Re: Indian Point Unit No. 2
Docket No. 50-247
NL-00-099

Subject: Responses to the NRC's Request For Additional Information Regarding
Steam Generator Operational Assessment Report (TAC No. MA9288)

RESPONSES TO THE RAI QUESTIONS FROM NRC LETTER DATED JULY 20, 2000

CONSOLIDATED EDISON COMPANY OF NEW YORK, INC.
INDIAN POINT UNIT NO. 2
DOCKET NO. 50-247
JULY 2000

**Figure RAI-1-1. Indian Point-2: POD vs. Burst Effective Crack Area
Nominal, Lower 95% and Lower 99% Confidence Levels**

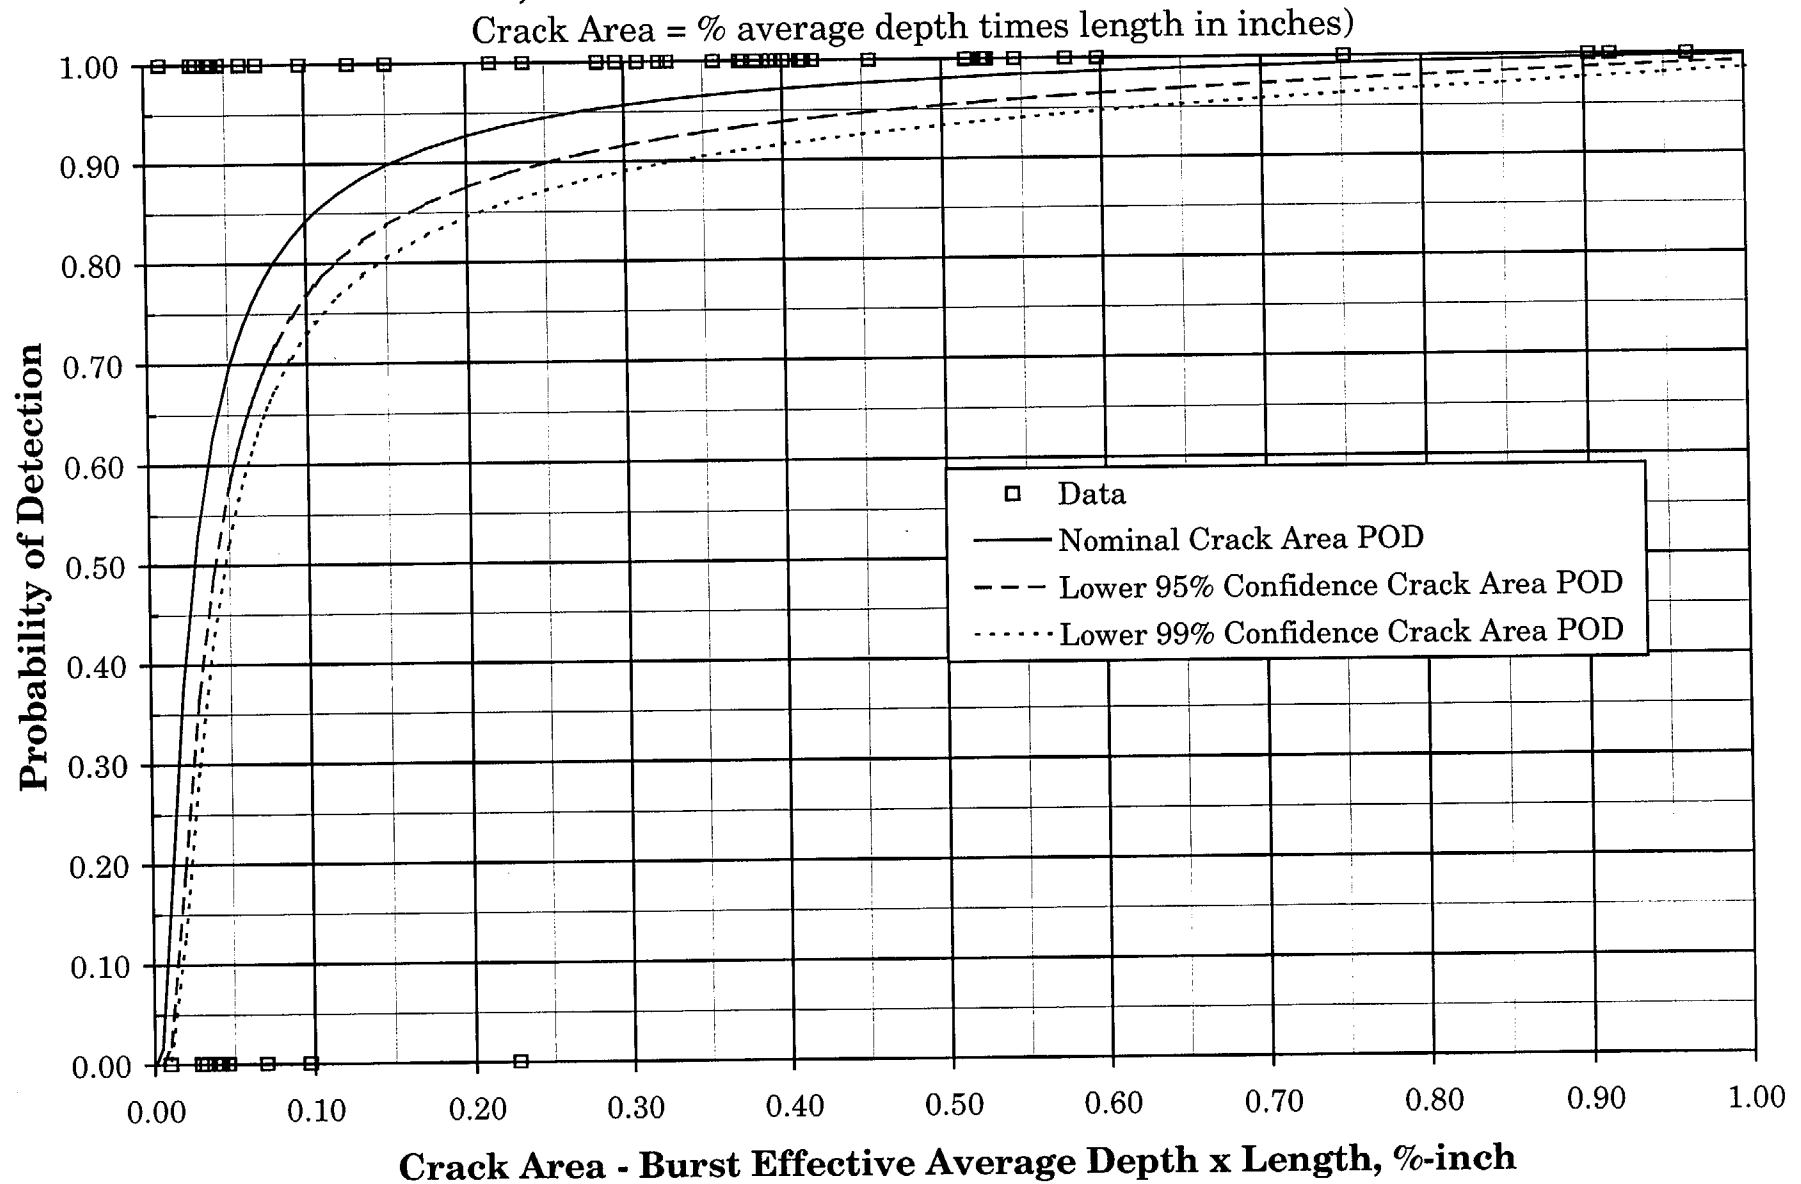
The July 7, 2000, submittal from Consolidated Edison Company of New York, Inc. (the licensee) refers to the consideration of an uncertainty distribution that was applied to the depth-based and area-based probability of detection (POD) curves for the low row U-bends. Confirm whether the staff's understanding is correct that the assumed uncertainty distribution refers to the full uncertainty range of the nominal fit to the data. Provide a chart illustrating the 95 percent confidence bounds on the nominal POD fit to the crack area data (similar to that done in Figure 6-1 for the nominal fit to average crack depth).

Figure RAI-1-1 provides the requested plot of the nominal and lower 95% confidence POD fit to the crack area data. The plot also includes the lower 99% confidence POD curve. The lower 99% confidence curve is included to permit comparisons of a defined confidence level with the Question 3 request to provide sensitivity analyses for a 50% and 100% shifts of the nominal crack area based POD function.

Figure RAI-2-1. Indian Point-2: POD vs. Average Crack Depth Including PODs at Lower Confidence Levels and with Depth Shifts

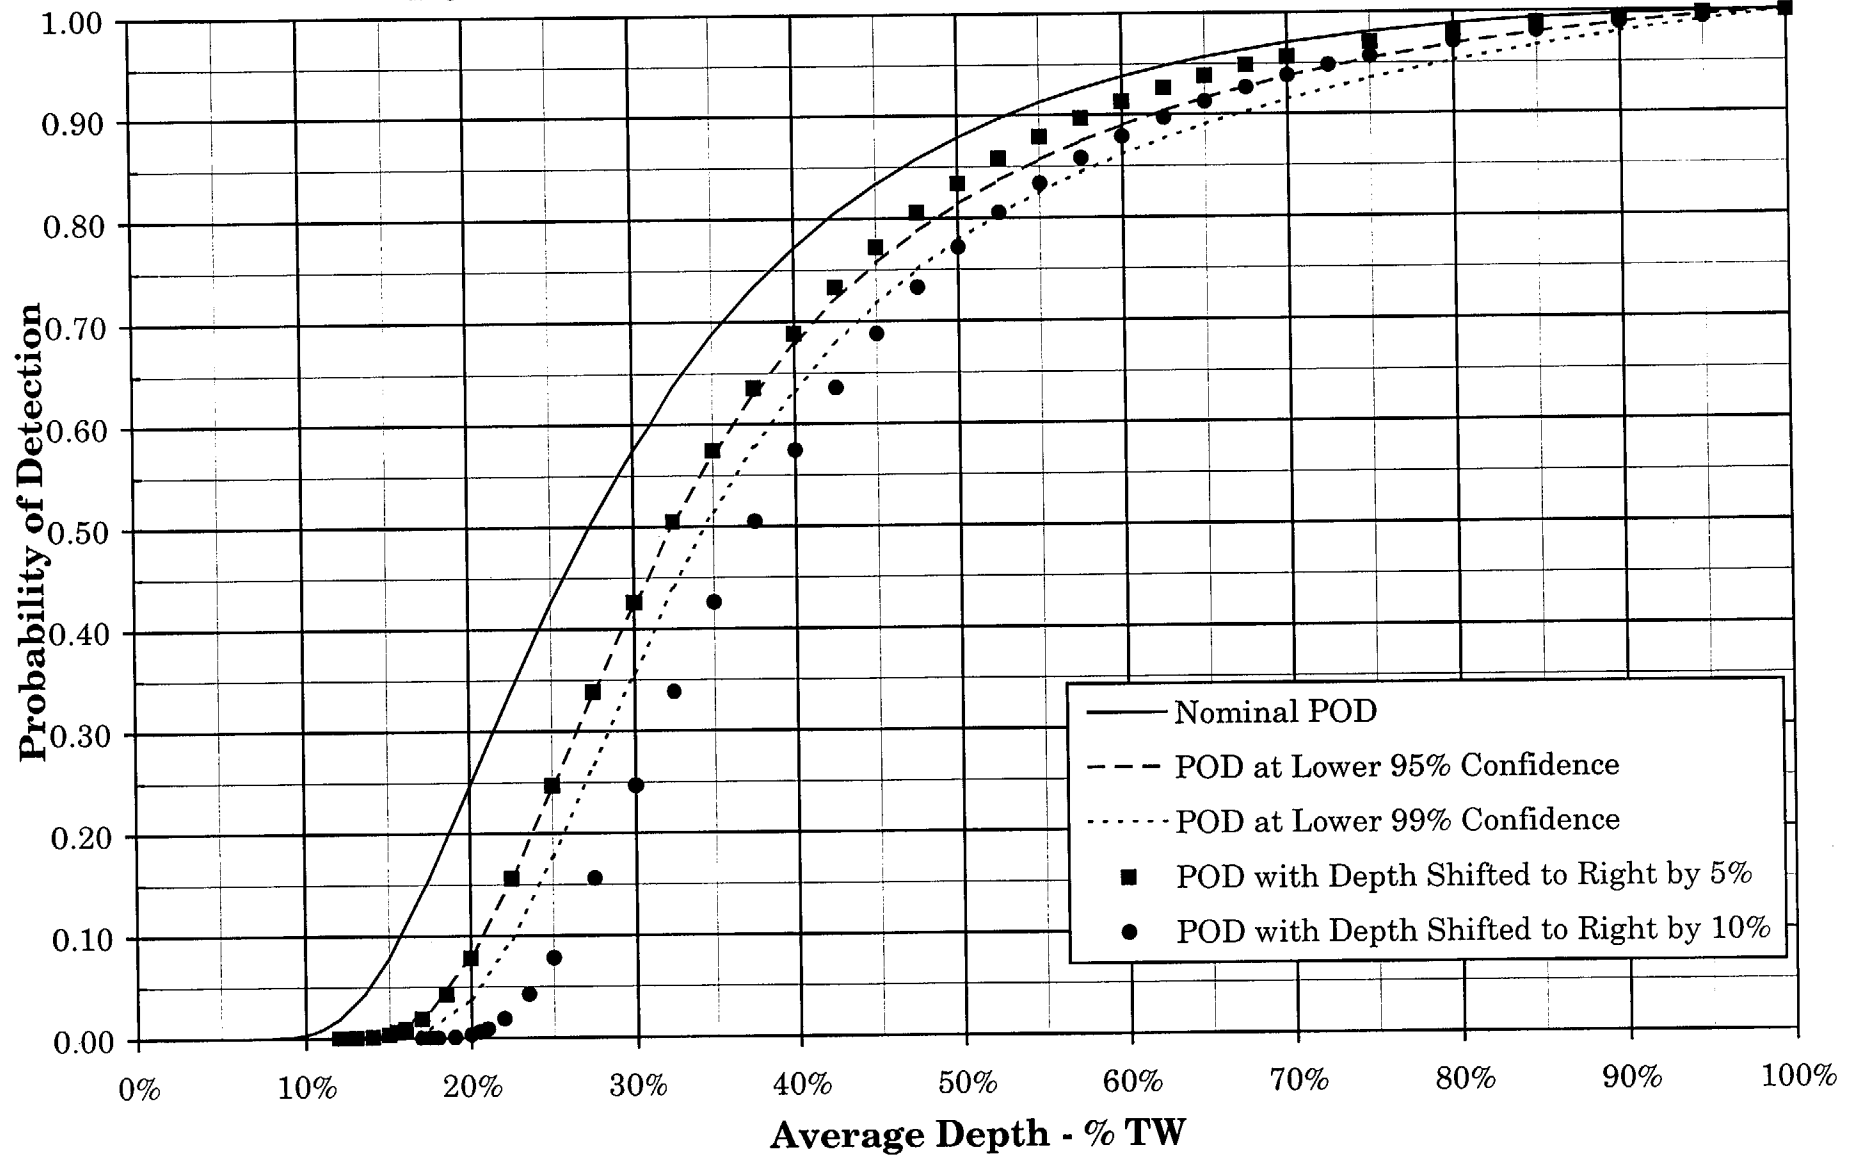
In its June 2, 2000 submittal, the licensee had previously provided the analysis sensitivity results for an assumed +5% shift of the depth-based POD in terms of percent through-wall. What is the sensitivity of the June 2 analysis to a 10% shift?

The 5% and 10% shifts in the nominal depth-based POD function are obtained by adding 5% and 10% average depth to the nominal depth at each POD value. This provides a lateral shift in the POD by 5% and 10% depth to more conservative POD functions. In Figure RAI-2-1, the nominal and shifted PODs are compared with the average depth POD uncertainty distribution evaluated at the lower 95% and lower 99% confidence levels. The POD with a 5% depth shift is in good agreement (about 1 to 2% in POD higher above 45% depth) with the POD evaluated at the lower 95% confidence level. However, including this POD in the Monte Carlo analyses is equivalent to deterministically applying the lower 95% POD for all indications. This practice is much more conservative than the required evaluation of the burst distribution at a 95/95 confidence level including POD uncertainties in the analysis. The POD with a 10% average depth shift is more conservative than the POD at the lower 99% confidence level for crack depths less than 50% and slightly less conservative (1 to 2% on POD) for crack depths above 55%. It should be noted that analyses at 99% or greater confidence levels are unprecedented in the level of conservatism (statistical 99% and even more conservative for deterministic 99% POD applications) for SG tube integrity analyses by any existing NRC or EPRI or other industry guidelines. As a result, such analyses are not considered applicable or necessary for assessing the Indian Point-2 acceptable operating cycle length.

**Figure RAI-3-1. Indian Point-2: POD vs. Burst Effective Crack Area
Including PODs at Lower Confidence Levels and with Crack Area Shifts**

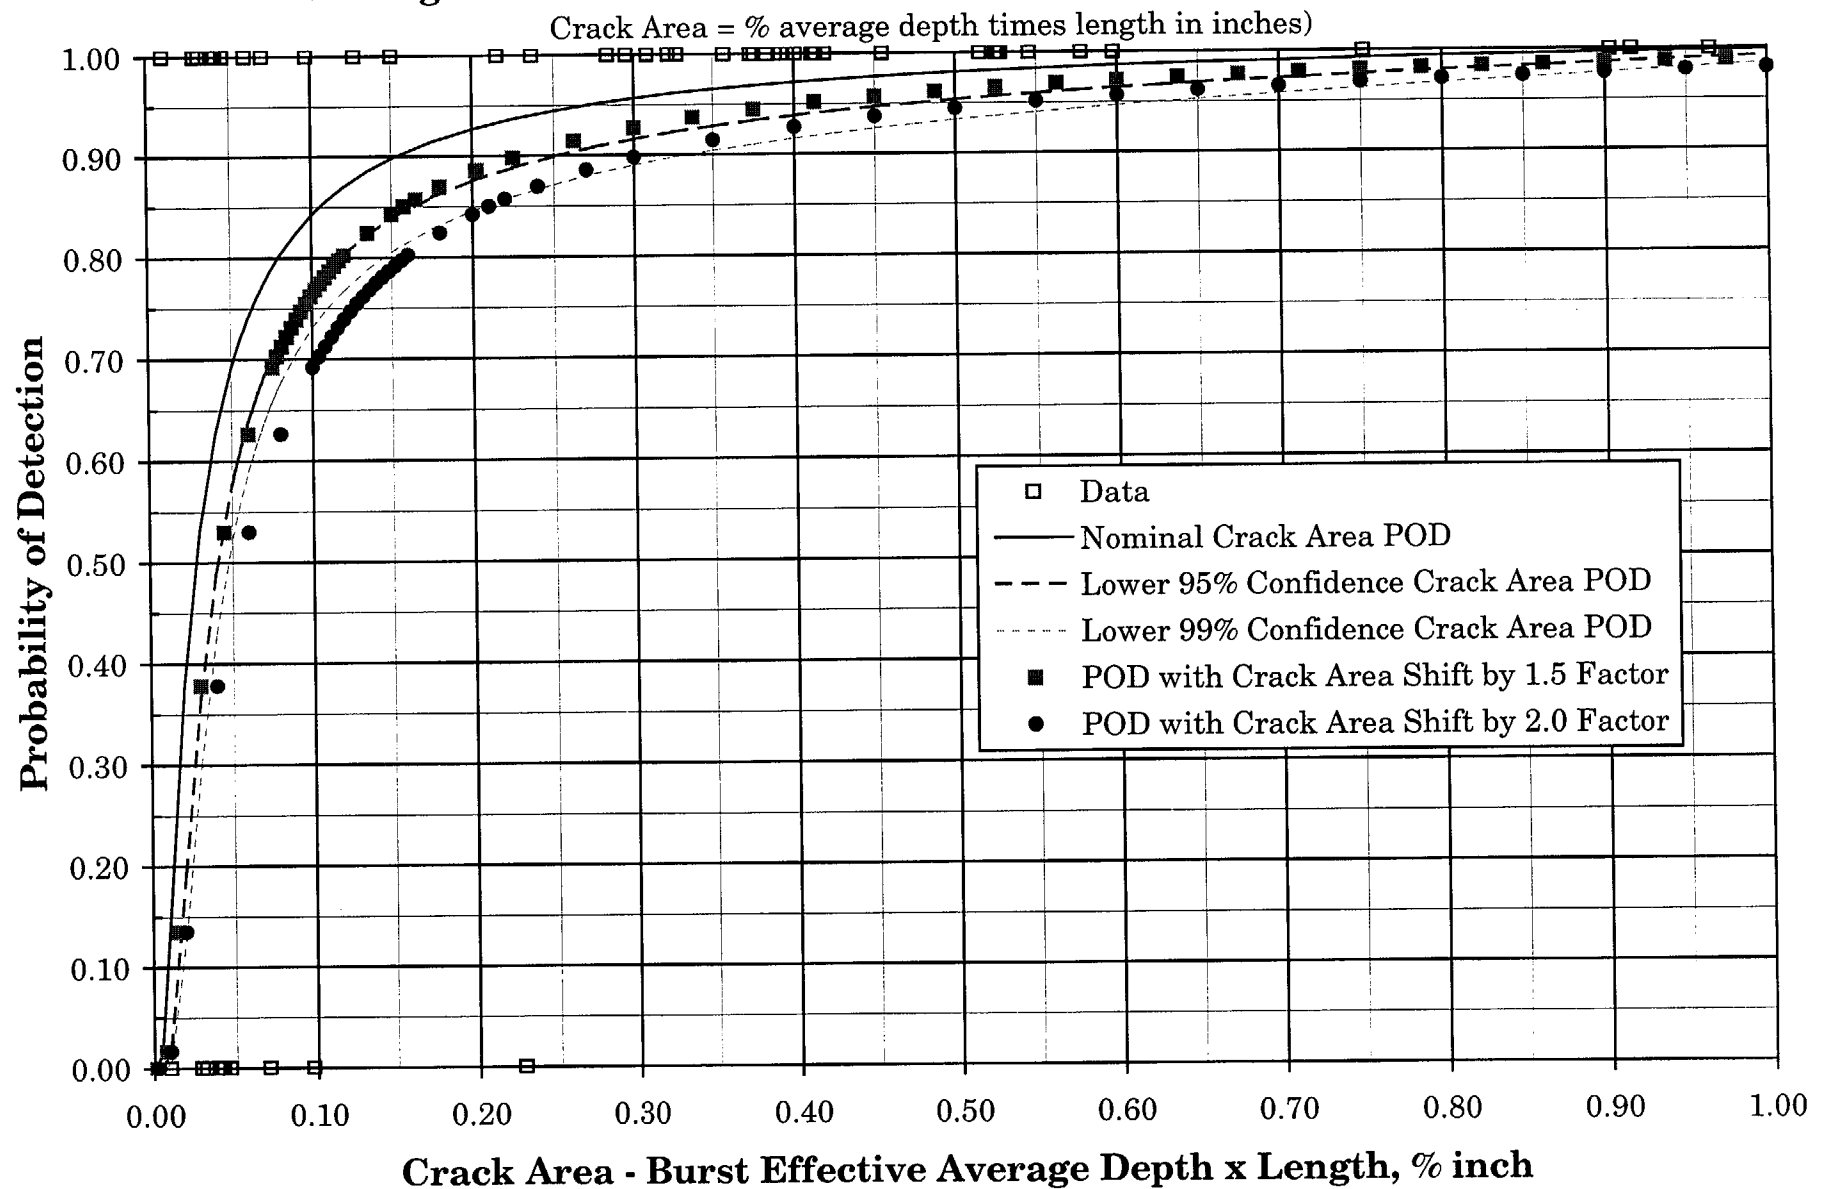
In its July 7 submittal, the licensee did not describe the sensitivity of the supplemental analysis results to a shift in the nominal crack area-based POD function. Provide the sensitivity of the analysis results to a 50% and 100% shift of the nominal area-based POD function in terms of crack area for a given POD value.

The 50% and 100% shifts in the nominal area-based POD function are obtained by multiplying the nominal area at each POD value by factors of 1.5 and 2.0, respectively. This provides a lateral shift in the POD conceptually similar to that for the 5% and 10% shifts in the POD for Question 2 above. In Figure RAI-3-1, the nominal and shifted PODs are compared with the POD uncertainty distribution evaluated at the lower 95% and lower 99% confidence levels. The crack area POD with a 1.5 factor shift is in good agreement (1% on POD) with the POD evaluated at the lower 95% confidence level.

The crack area POD with a 2.0 factor shift is more conservative than the POD at the lower 99% confidence level for crack areas less than 0.25 and slightly less conservative (1 to 2% on POD) for crack areas above 0.25. The row 2 indications found in the year 2000 inspection have crack areas of 0.03 to 0.14 %-inch for the 8 smaller indications and 0.29 to 0.46 %-inch for the 3 largest indications. Analyses at 99% or greater confidence levels are unprecedented in the level of conservatism for SG tube integrity analyses required by any NRC or EPRI guidelines, and are not considered appropriate for assessing the Indian Point-2 acceptable operating cycle length.
